## Product Change Notification

### PCN-ICC-6790-2021

Business Unit	Product Line Code	Type of Change	Action	Date of Issue
ICC - Industrial Cabinet	BE2	Product Change Notification	Notify Distributors and Field	4/26/2021

#### Description for Product Change Notification

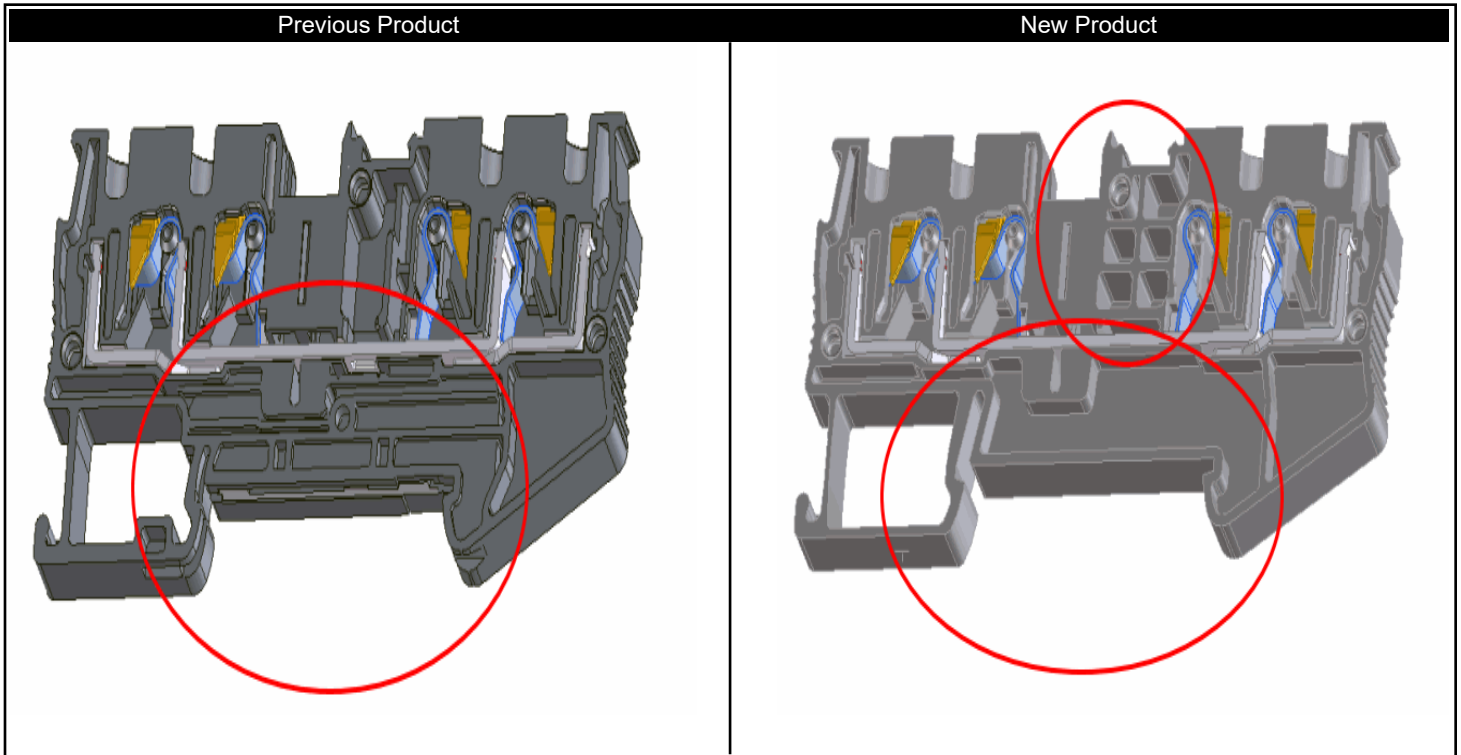
Housing change; removal of the groove for the -PE foot and the inner, lower rib structure. No changes on electrical/mechanical function or accessories.
